S A V A N N A H H I S T O R I C D I S T R I C T
B O A R D O F R E V I E W

REQUEST FOR CERTIFICATE OF APPROPRIATENESS

MPC File No.: 26-001855-COA

Address: 318 East Huntingdon St.

April 2016 Street View

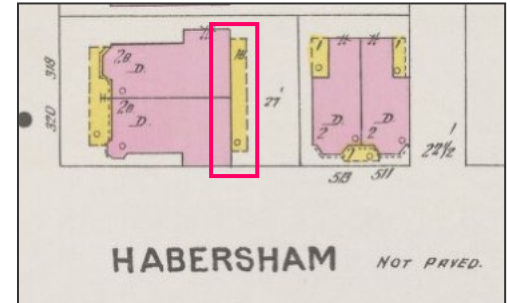
Google Street View images from 2016 and 2017 show what the rear porch looked like, in part, before the enclosure work began. In these images, the decorative wood porch elements can be

seen. These are still in existence but have now been enclosed with the current work that has taken place.
